Preliminary Use Only

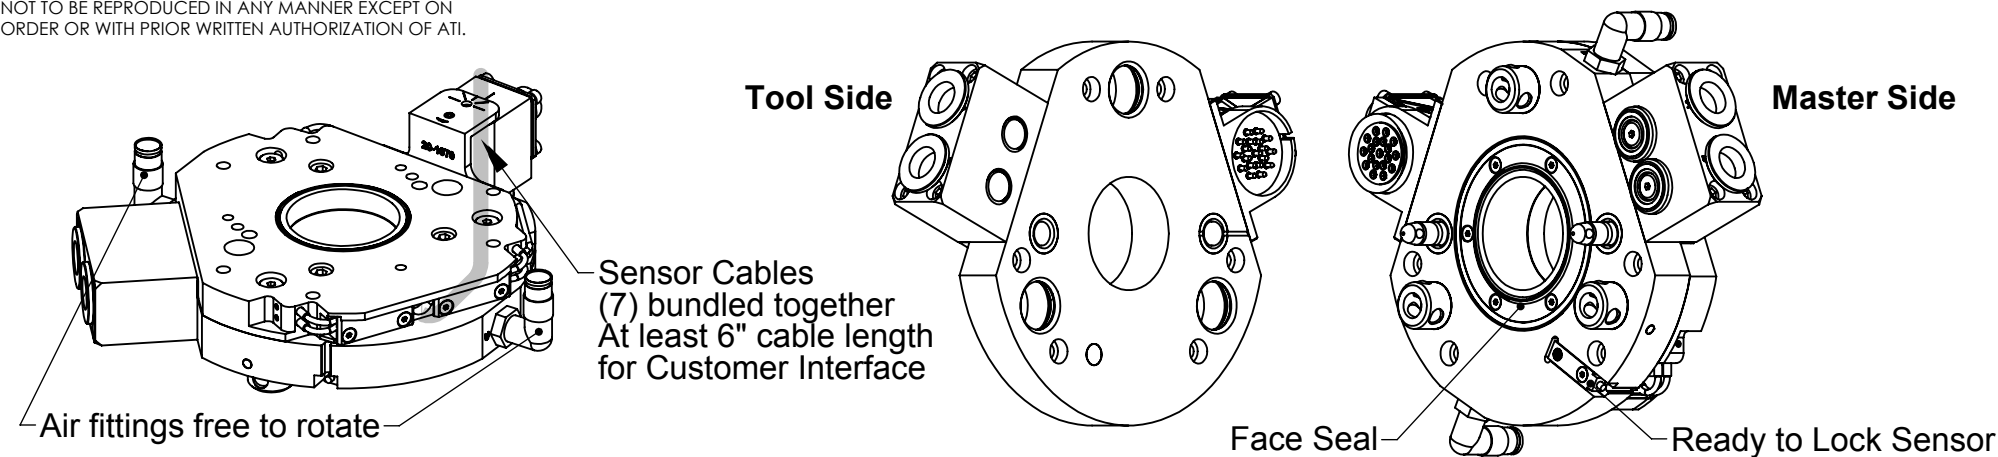
Rev.	Description	Initiator	Date
02	Second Concept	MJG	12/24/2007
03	Changed thru hole to 45 mm. Decreased O.D. to 152.4 mm. Replaced 'R' modules with 'G' modules. Decreased stack height. Replaced mechanical switches with 4 mm proximity sensors. Individual sensor cables run as a bundle out of QC. Mounting locations for modules and Lock/Unlock ports changed.	MJG	1/14/2008
04	Added sensor cable requirements.	MJG	1/16/2008
05	Sensor Cable Bundle redrawn. Alignment pin height increased from 15.2 to 19.4. Viton o-rings used for sealing thru hole, Note 7. Updated models.	MJG	3/18/2008
